Sugarmill Road Large Lot Residential Precinct 28, 35 and 89 Sugarmill Road; Sapphire Beach

Traffic and Transport Impact Assessment

SUGARMILL ROAD ASSESSMENT PROPOSED SUBDIVISION OF LOTS 12, 19 & 91.

RE: Planning Proposal PP-2022-107, 28, 35 and 89 Sugarmill Road Sapphire Beach

RECOMMENDED PAVEMENT WIDENING, SUGAR MILL ROAD

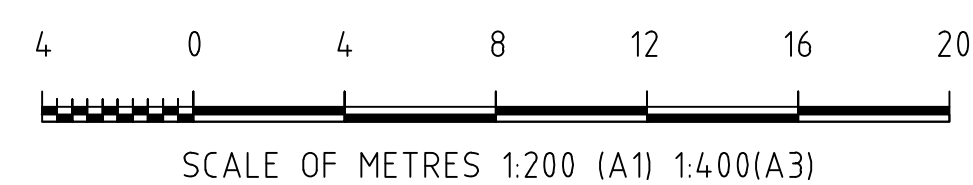
One section, the narrowest, does warrant some widening works. The third drawing attached shows the bend between CH 140 and 280 where the seal is at its narrowest. Being on a bend with reduced sight distance, widening of the seal to at least 6.0 m is warranted, with this work best undertaken on the north side (inside of bend). Further, the longitudinal gradient through the section is quite flat as the road also passes over a gentle crest. Accumulated sediment and grass growth has all but filled the original shallow table drain on the north side. With the seal widening, the reshaping of a 1m wide gravel shoulder and a deepening of the grass table drain should also be undertaken.
